REMEDIATION SYSTEM EVALUATION

FORMER OCCIDENTAL FACILITY
TACOMA, WASHINGTON

Report of the Remediation System Evaluation,
Site Visit Conducted at the Former Occidental Facility, Tacoma, Washington
July 8, 2003

EPA 542-F-04-026
August 2004
www.epa.gov/tio
clu-in.org/optimization

FIGURE 1-3. PLANT EAST/WEST GEOLOGIC CROSS-SECTION.

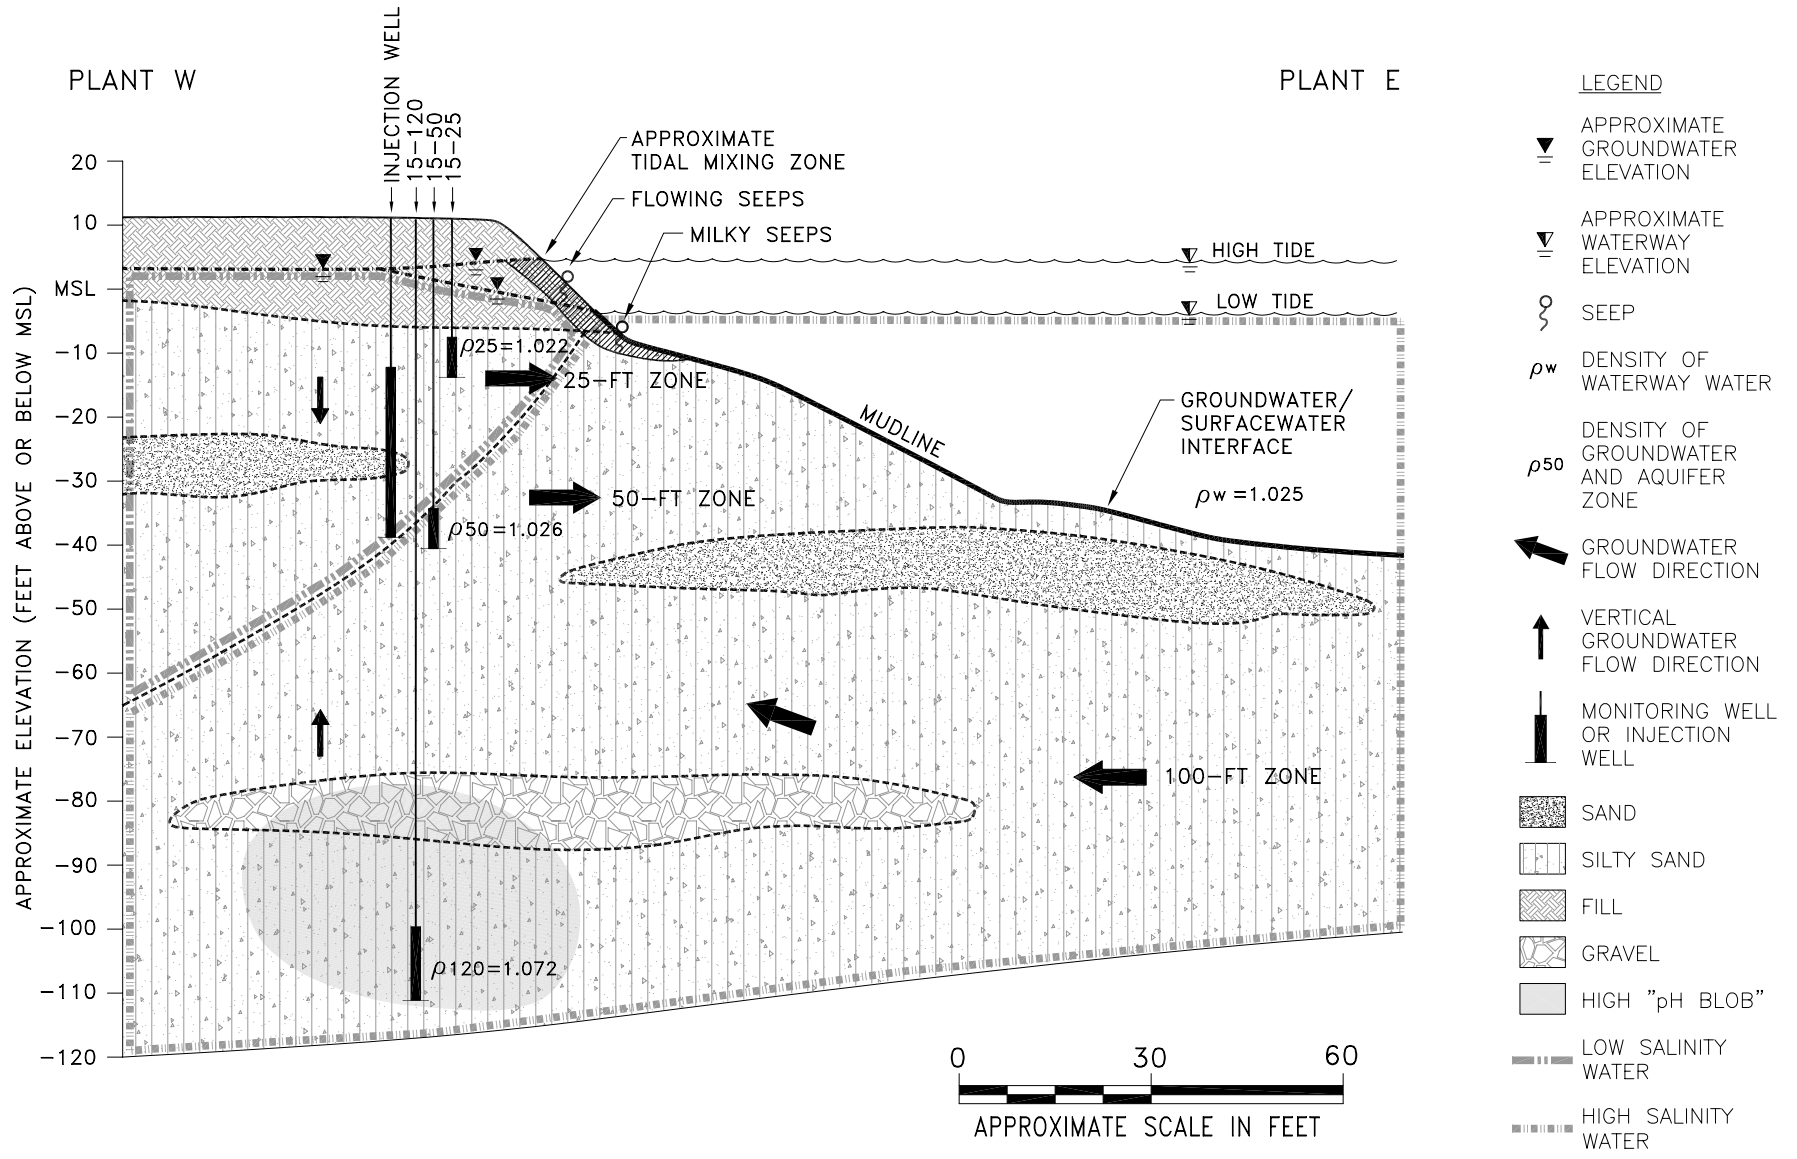
Most of the site monitoring wells are screened in three intervals that are approximately 25, 50, or 100 feet below ground surface within the fluvial deposits. Ground water contamination is generally tracked in each of these intervals but a number of wells are also completed at greater depths. Figures 1-4 through 1-6 show the extent of VOC contamination and the areas with pH over 10 for the 25, 50, and 100-foot depth intervals, respectively. The elevated pH at the 100-foot interval corresponds to the “pH blob” identified in Figure 1-3.

FIGURE 1-6. EXTENT OF CONTAMINATION AT 100 FEET BELOW GROUND SURFACE - AUGUST 2002

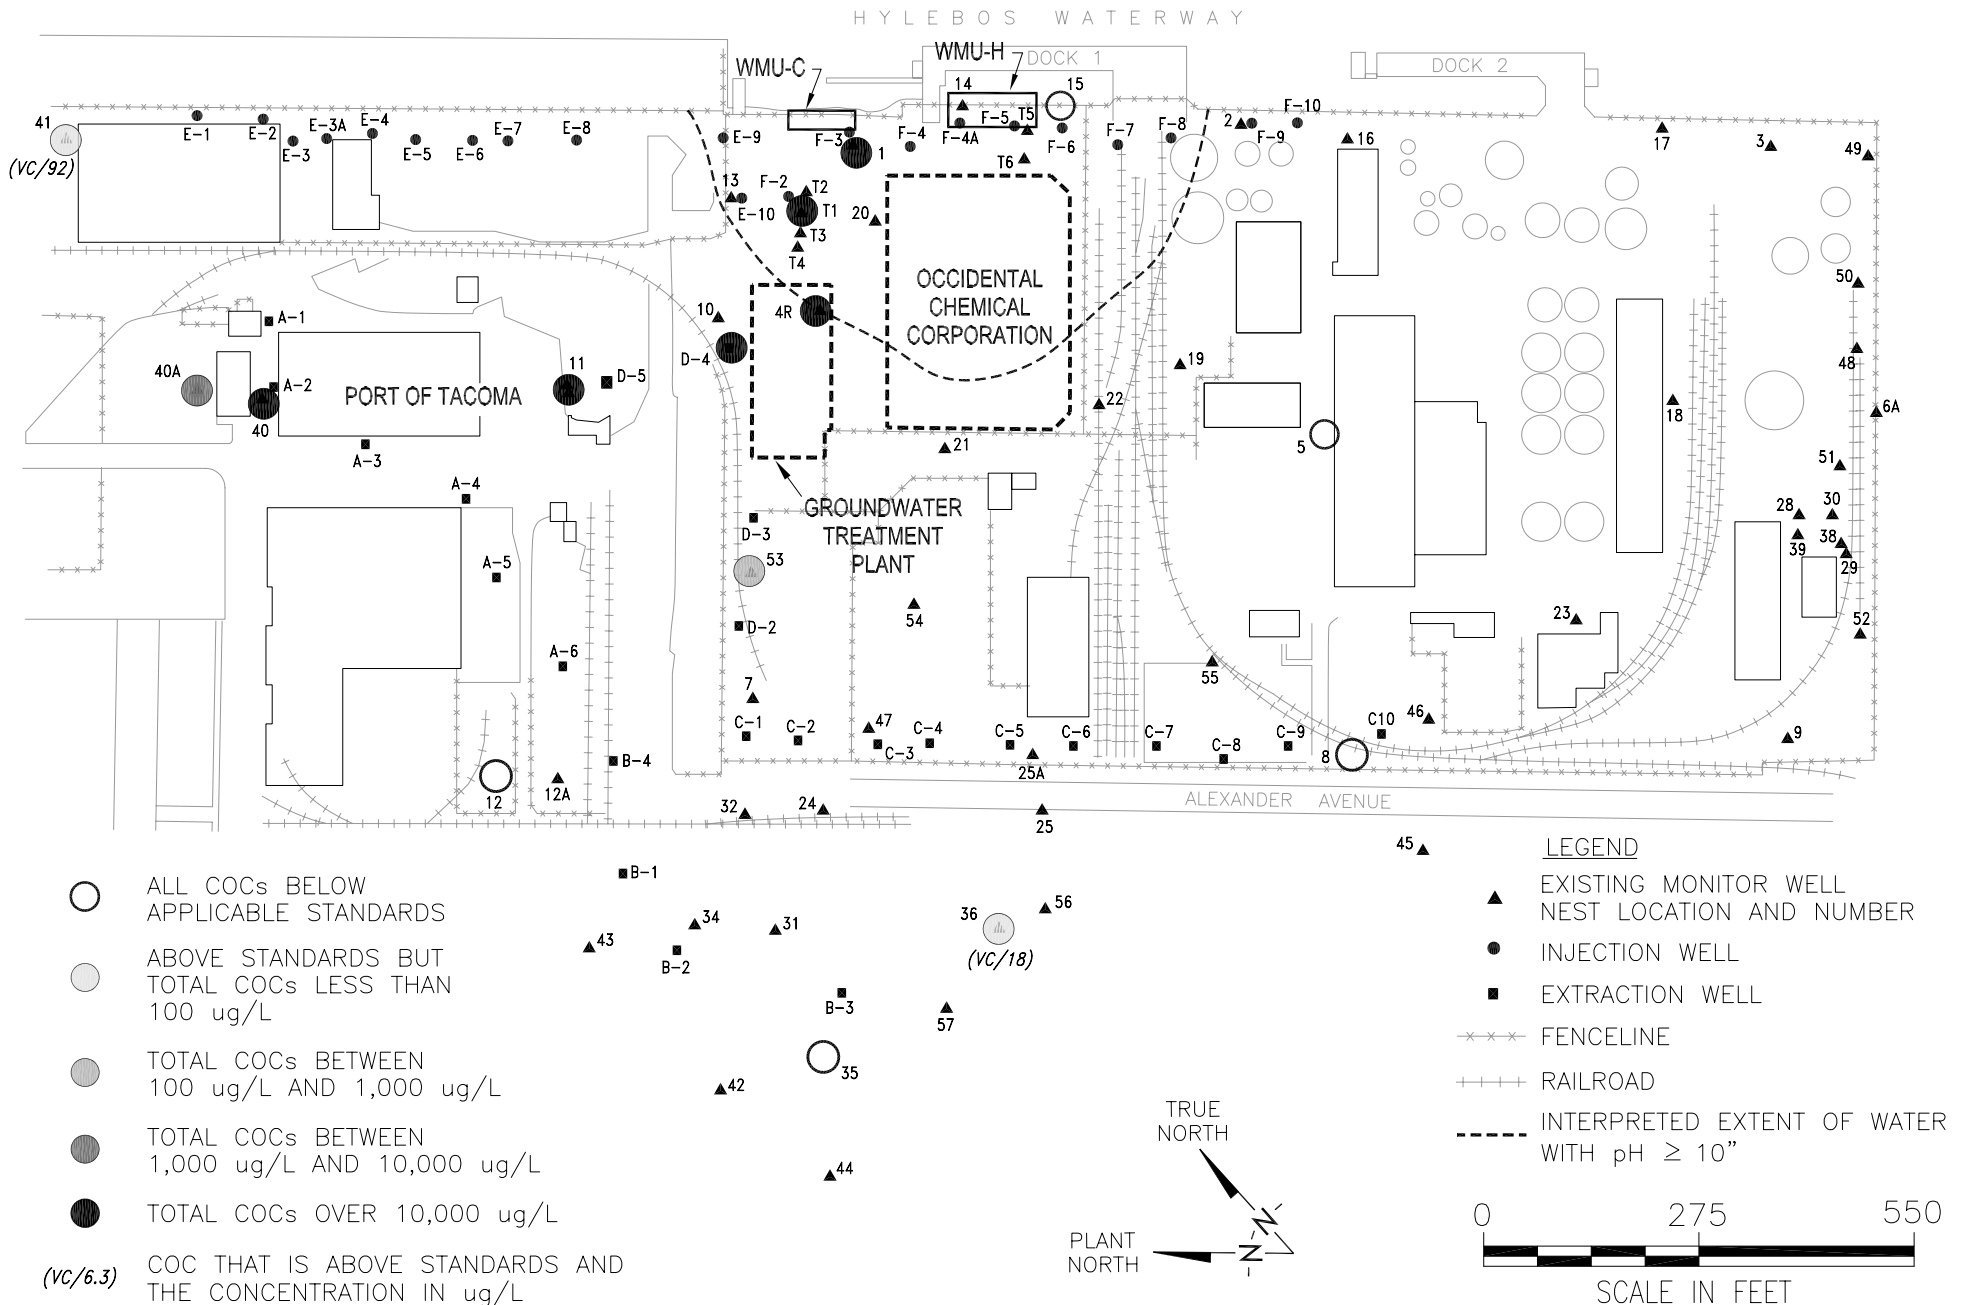
Capture at the 100-foot depth interval is inconclusive due to a lack of data, and a thorough capture evaluation at this depth is also complicated by the lack of plume delineation. In particular, the concentrations at monitoring wells 41-138, 40A-100, and 40-100 all have VOCs well above relevant cleanup standards, and there are no monitoring wells or extraction wells downgradient of these locations to provide delineation. The substantial decrease in VOC concentrations in 41-138 could be interpreted as an indication of capture, but the decrease started well before the addition of A-2A. Therefore, the decrease is likely due to dilution from the injection of clean water at E-1 and the movement of contaminated water further from the site. The increases in VOC concentrations at 40A-100 and 40-100 might indicate that these wells are within the capture zones of nearby extraction wells and that contaminated ground water is passing through these monitoring wells on route to extraction at A-2A. It could also potentially represent uncaptured contamination. Moreover, substantial contamination may exist beyond 40A-100 and 40-100 given that these two wells have substantial concentrations (38,000 ug/L of total contaminants of concern at 40-100 and 9,800 ug/L of total contaminants of concern at 40A-100 in August 2002) and no monitoring points are available to the north.

- Additional monitoring wells are needed to delineate the VOC plume to the north approximately 100 feet below ground surface. The RSE team estimates that approximately four wells to this depth will be needed.

FIGURE 1-7. EXAMPLE POTENTIOMETRIC SURFACE MAP FOR THE 25-FOOT INTERVAL (JANUARY 2002) SUBMITTED AS PART OF AN ANNUAL PERFORMANCE EVALUATION REPORT.

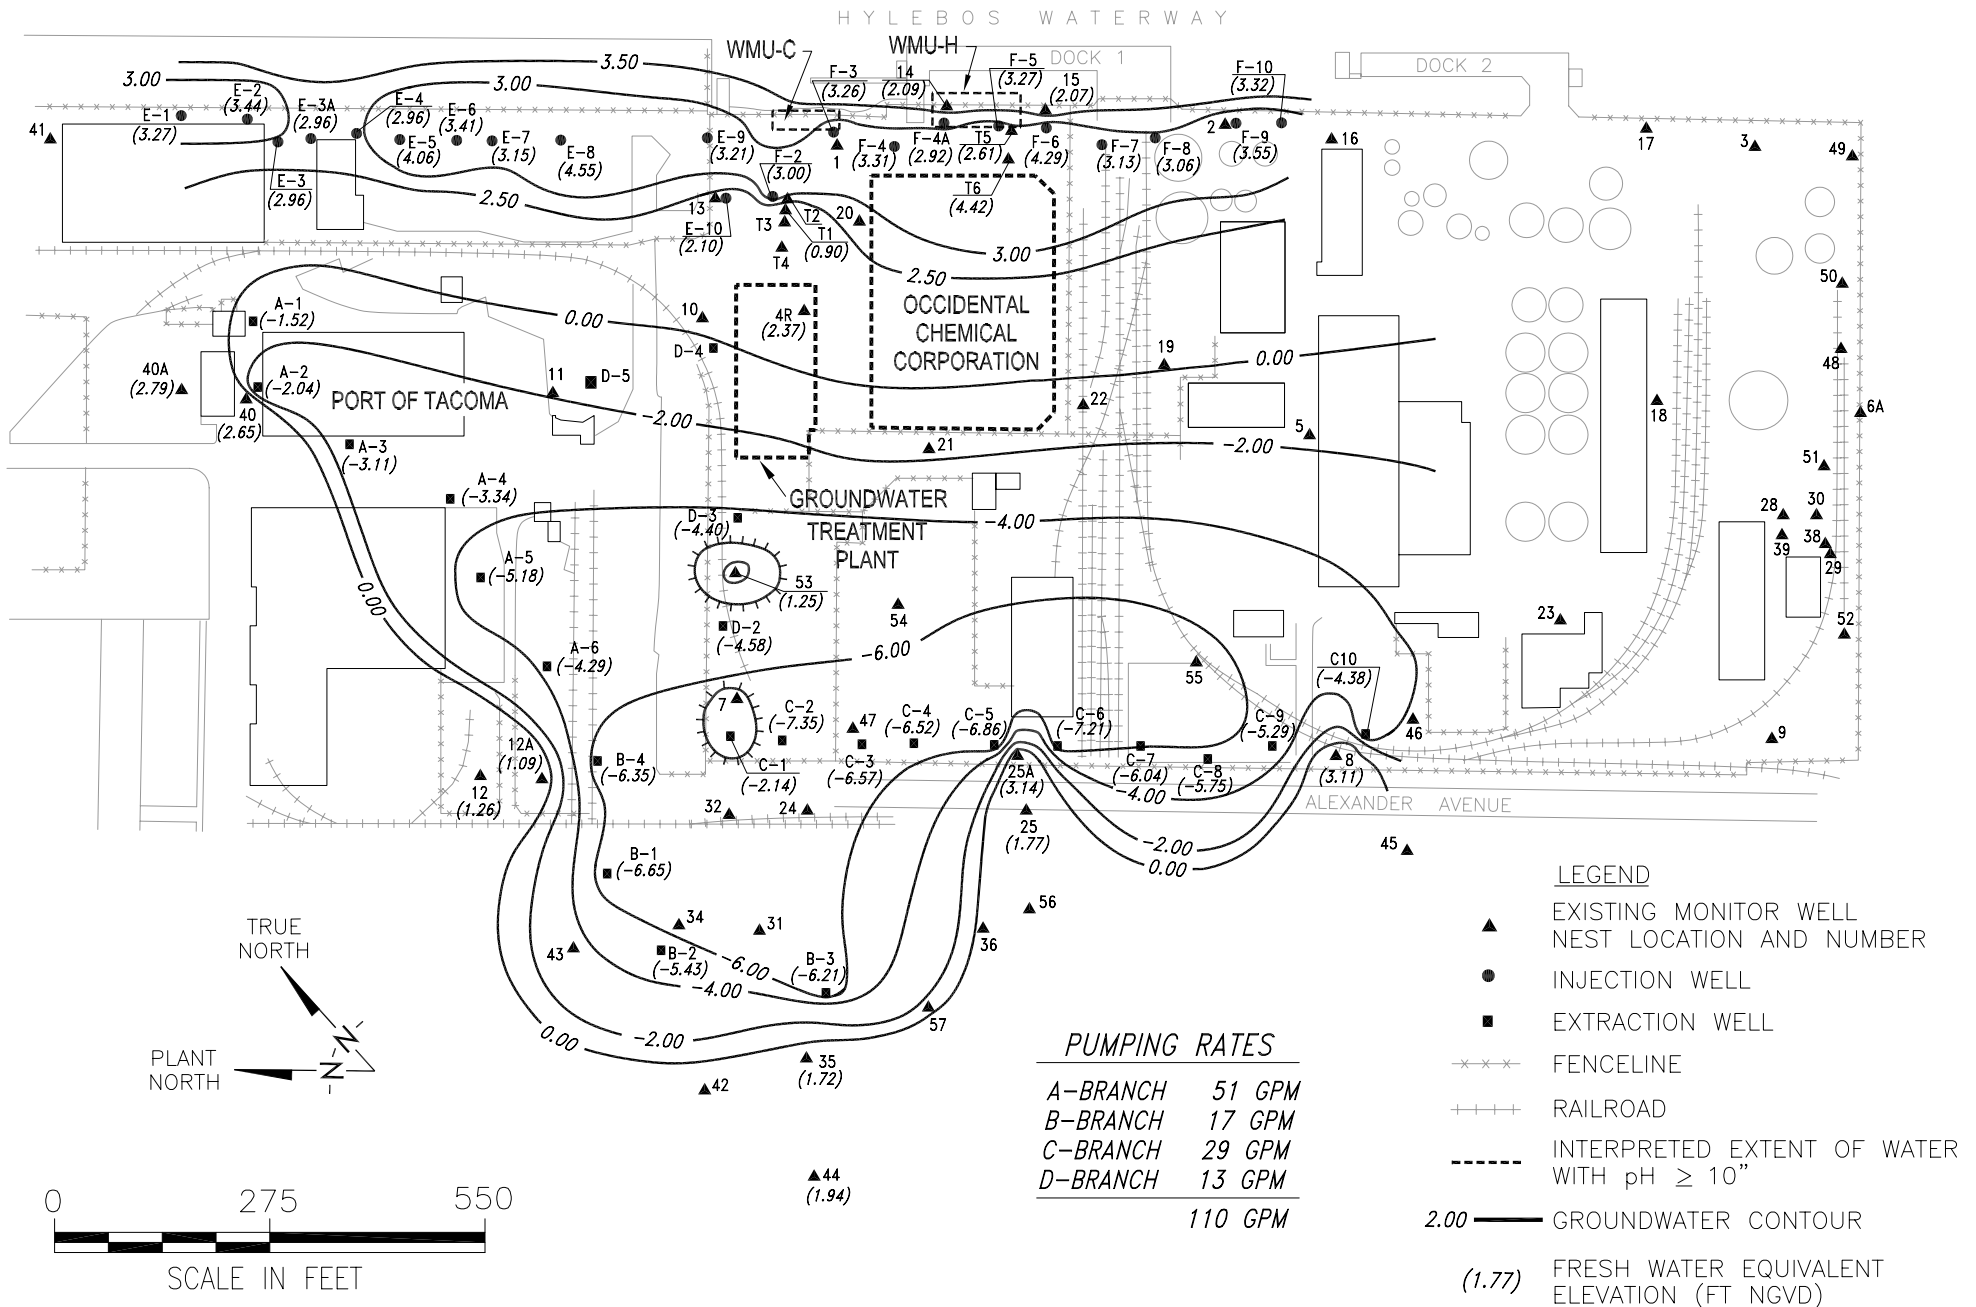
Potentiometric surface maps are generated and reported for each of the three depth intervals (25, 50, and 100 feet bgs) on a quarterly basis. For the 25 and 50-foot intervals, the maps are generated using water levels from monitoring wells and operating injection and extraction wells. However, the water levels from operating injection and extraction wells are not likely indicative of aquifer conditions and using these maps to draw conclusions about plume capture is unreliable. Figure 4-1 provides an example of a potentiometric surface map generated from the January 2002 water level data. The RSE team notes the following inconsistencies from this particular potentiometric surface map and that similar inconsistencies are present in other submitted potentiometric surface maps.

Using data from monitoring wells (and not injection or extraction wells) would provide a different picture of ground water flow across the site. The following examples are provided:

- Plume capture should be enhanced by abandoning the current injection system and increasing extraction throughout the site, where practicable.
- Evaluation of plume capture through the use of potentiometric surface maps developed from site-wide water level measurements and tidal corrections should be discontinued and replaced with more cost-effective and reliable approaches.
